# PARTS & SERVICE NEWS

REF NO.	AT01070
DATE	May 18, 2001
(C)	Page 1 of 7

**SUBJECT:** REPAIR METHOD OF T/C TRUNNION BOSS ON HD785-3, 5/  
HD985-3, 5/330M

**PURPOSE:** To introduce a spare part to repair excessive wear of the trunnion boss section of torque converter on HD785-3/5, HD985-3/5 and 330M dump trucks and relevant modification procedures  
[Applicable to the rebuilt torque converter]

<Fig. 1> Contents of the modification

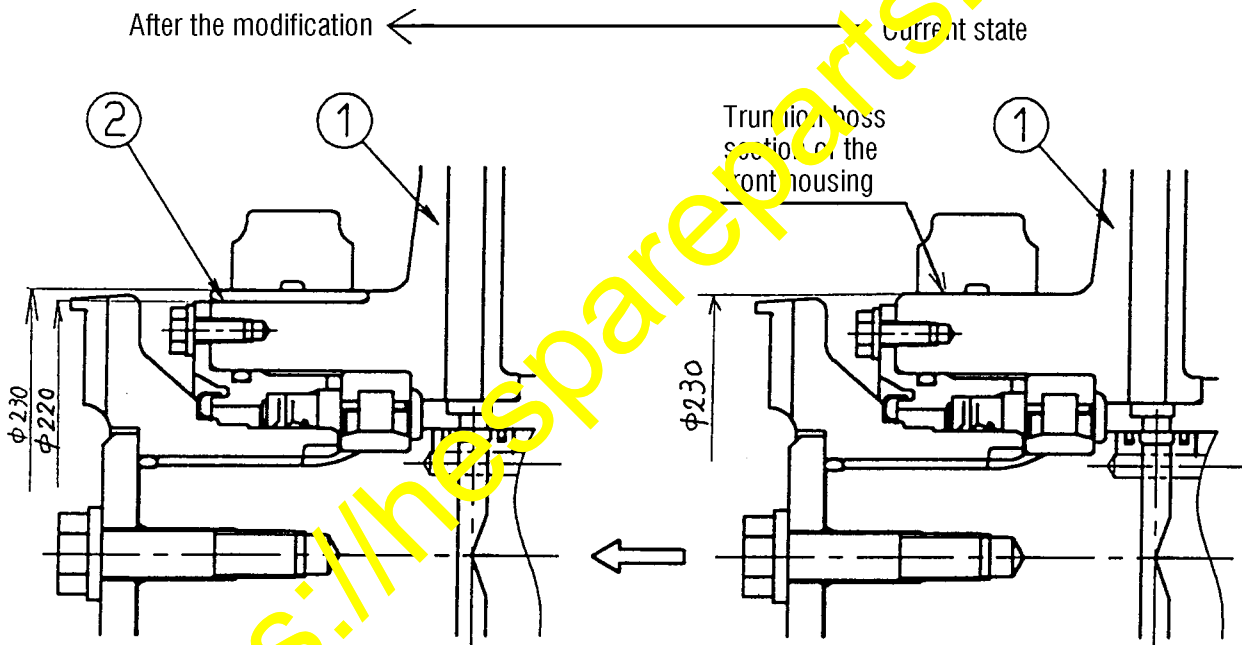
Rework the worn trunnion boss section of the front housing of the torque converter and press-fit a bushing.

No.	Part names	Part numbers	Contents of the modification
①	Front housing	561-13-43131	Machine the designated section of the trunnion boss from the current dimension of $\phi 230$ to $\phi 220$ .
②	Bushing	561-13-53380	New part (Press-fit it.)

&lt;Fig. 3&gt; Trunnion boss section

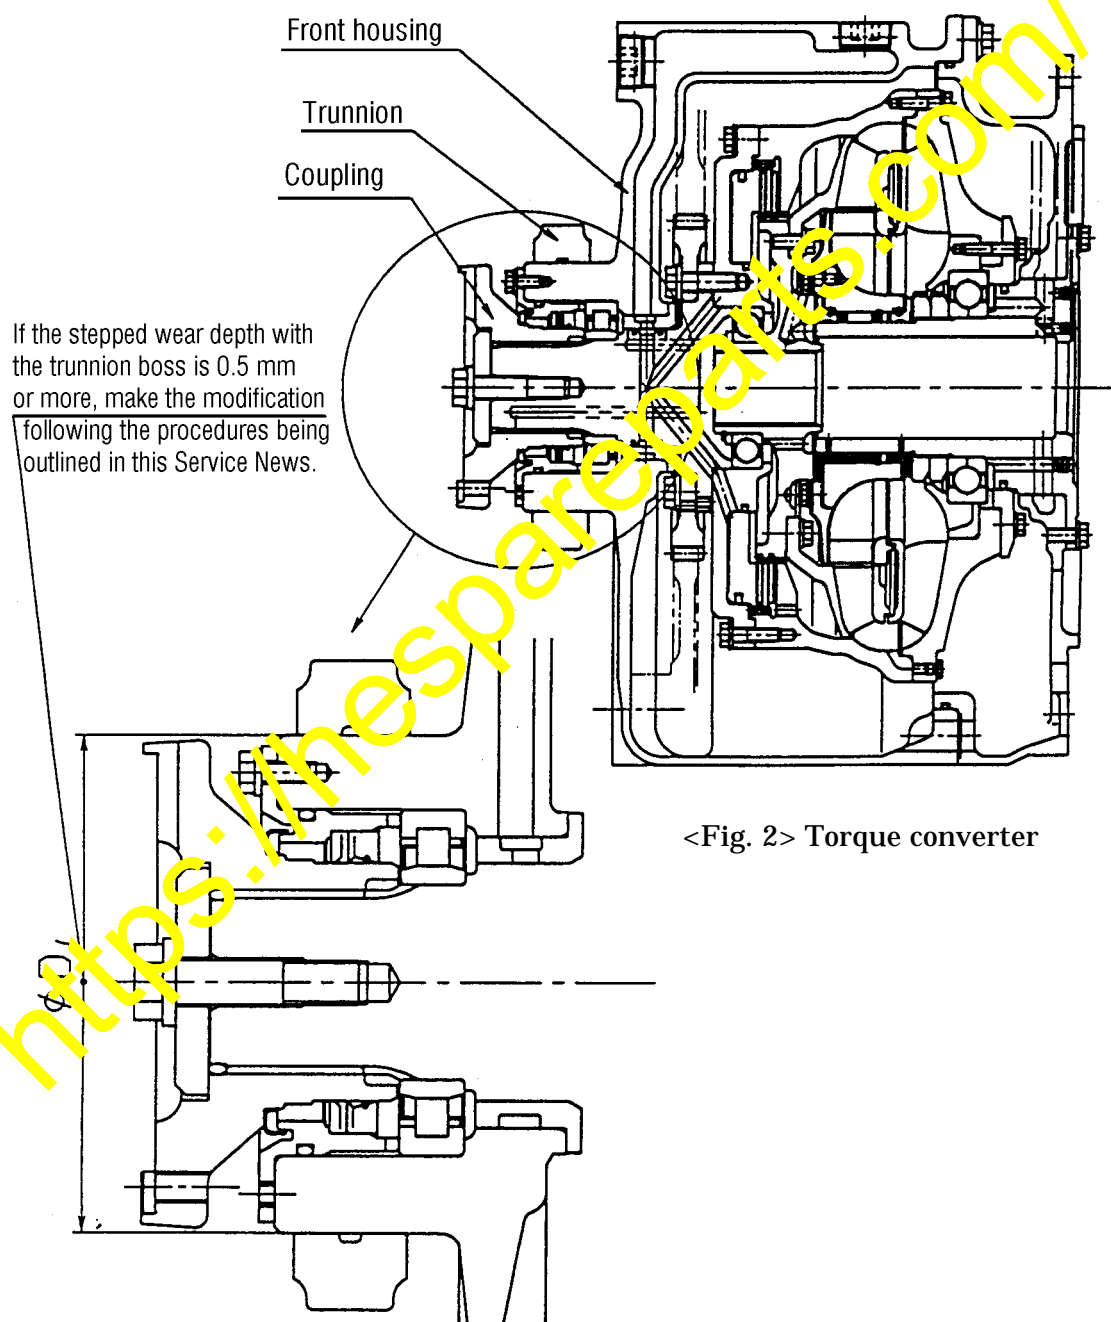
Checking point	Initial dimension	Criteria
Trunnion boss section of the front housing (The section "D1" in Fig. 3.)	$\phi 230 \begin{matrix} -0.100 \\ -0.172 \end{matrix}$	If the stepped wear depth with the trunnion boss is 0.5 mm or more, make the modification following the procedures being outlined in this Service News.

<Fig. 5> Machining procedures

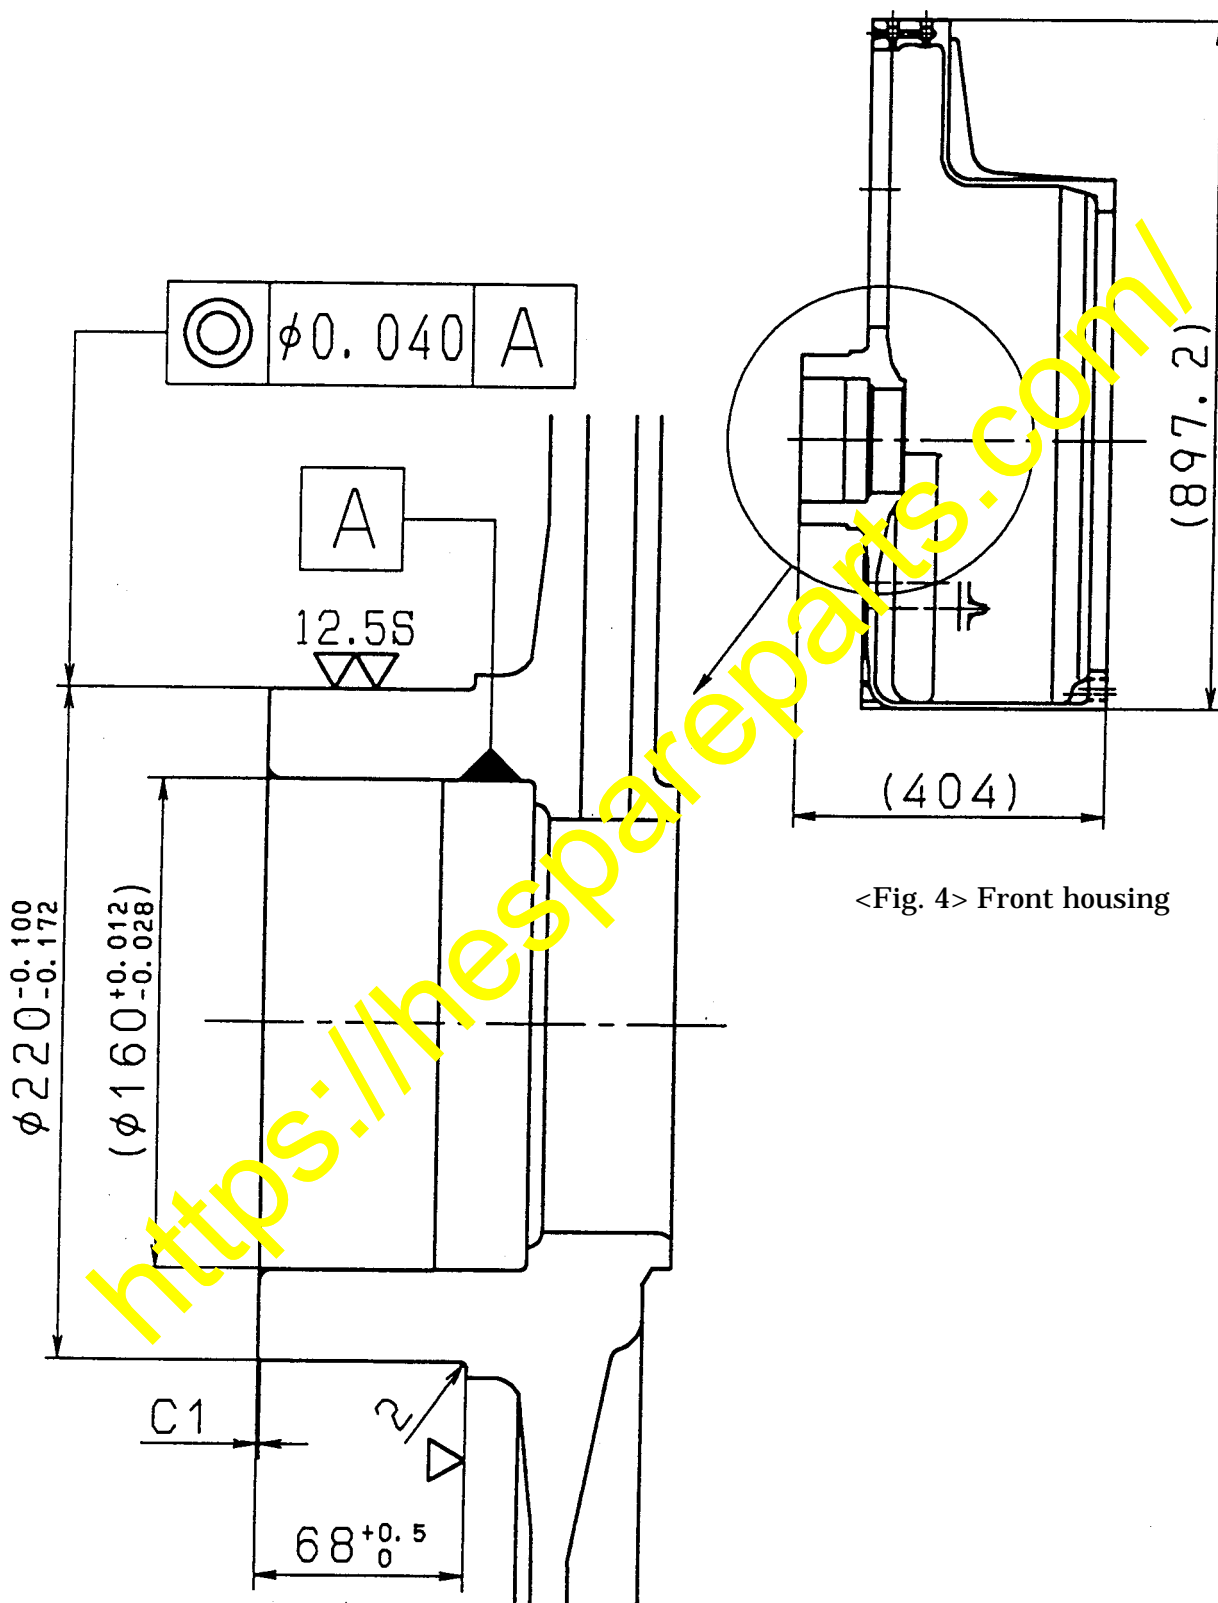
- (1) Rework the trunnion boss section of the front housing (561-13-43131) of the torque converter according to the instructions given in Fig. 5 below by machining.

<Fig. 6> Assembling procedures

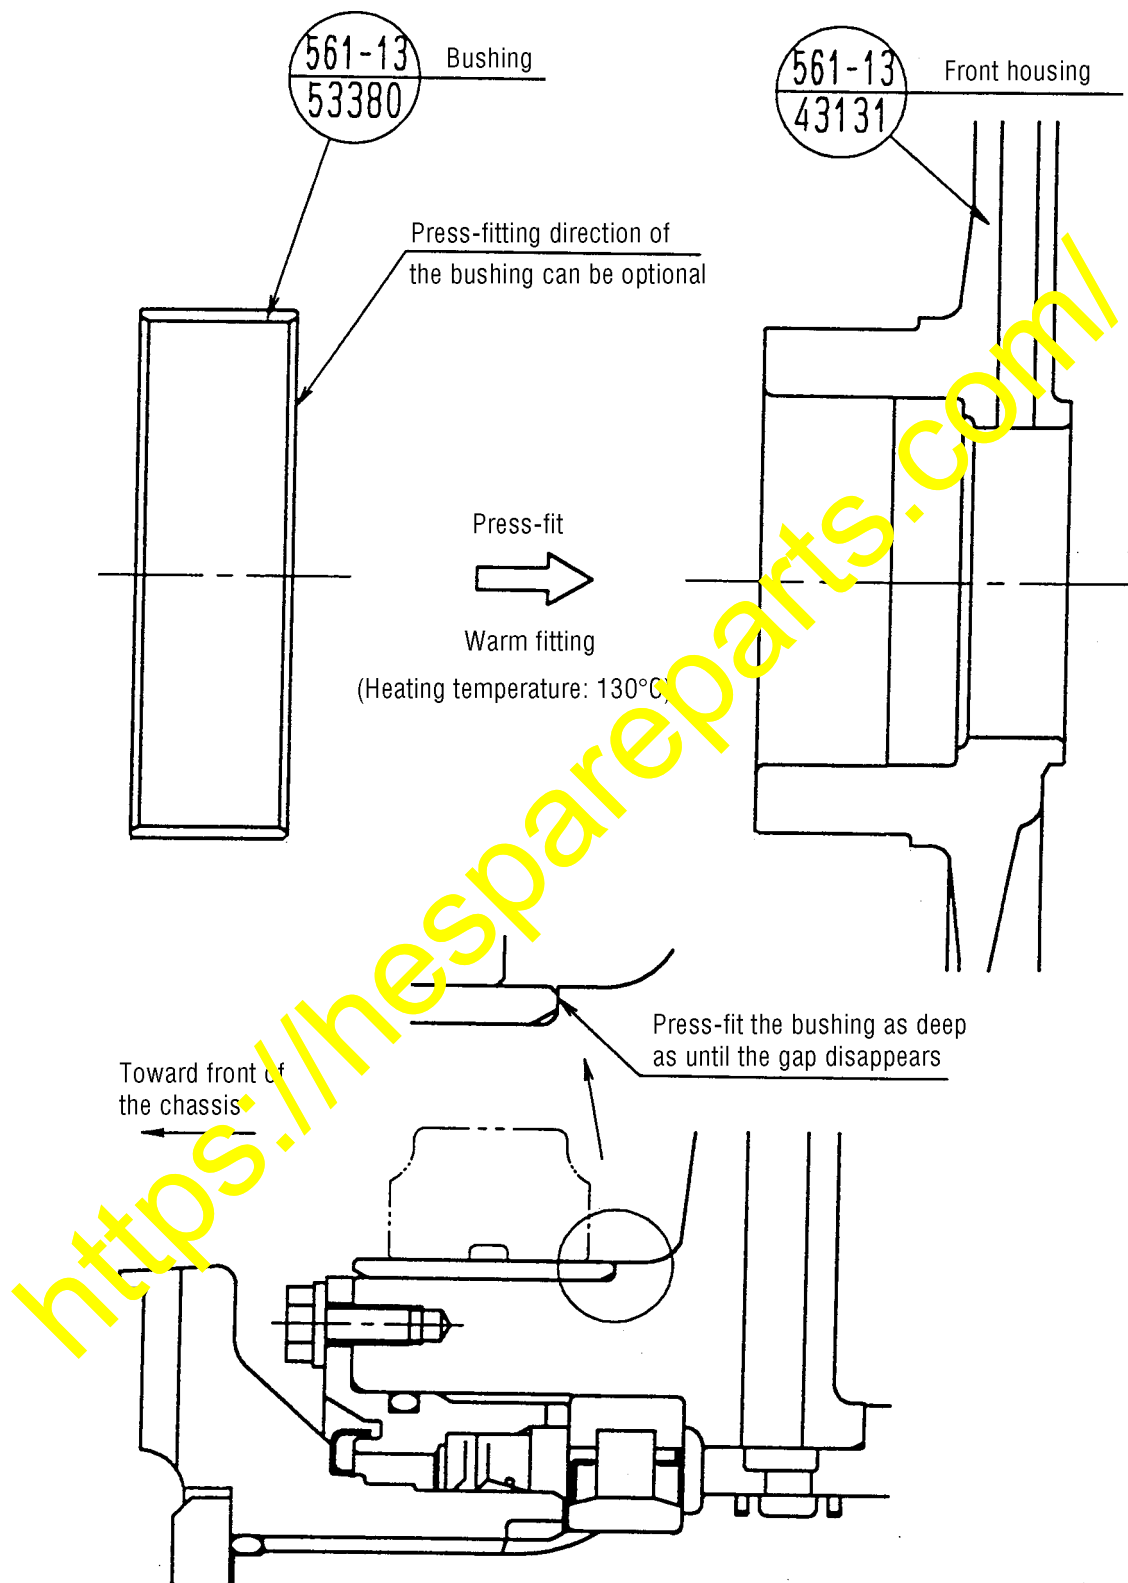
- (2) Heat up the bushing (561-13-53380) in a heating unit, etc. (heating temperature: 130°C) before press fitting to the machined section of the front housing.

<Fig. 7> Punching positions to fasten the bushing.

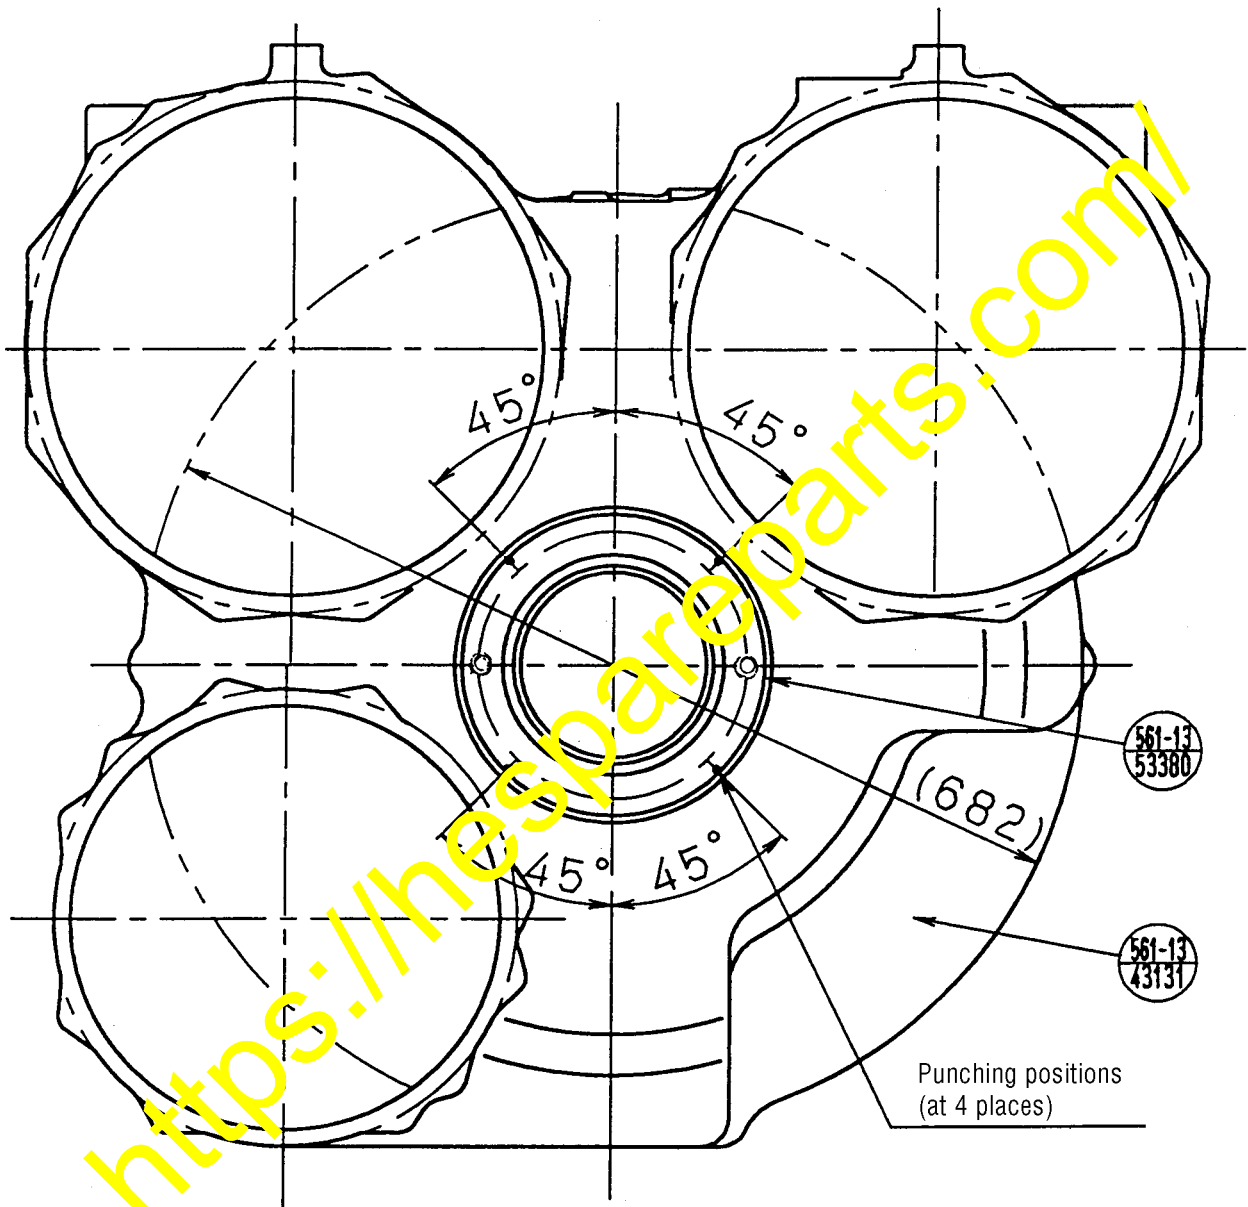
- (3) After press-fitting the bushing (561-13-53380) to the front housing, punch the positions marked • (around the peripheral edge of the front housing) using an appropriate punch until the punched projections dig into the bushing.  
Be sure to thoroughly remove burrs and fins resulting from the punching work.
